DESIGN STANDARDS BULLETIN

Appendix M – Building Signage

Date Issued: July 30, 2018

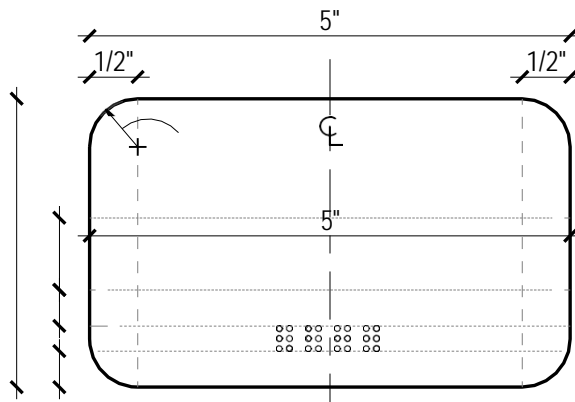
Signage in the exit stairwells, Sign Type K was incorrect per the current code.

Revise sign types J, K and K.1 per the attached.
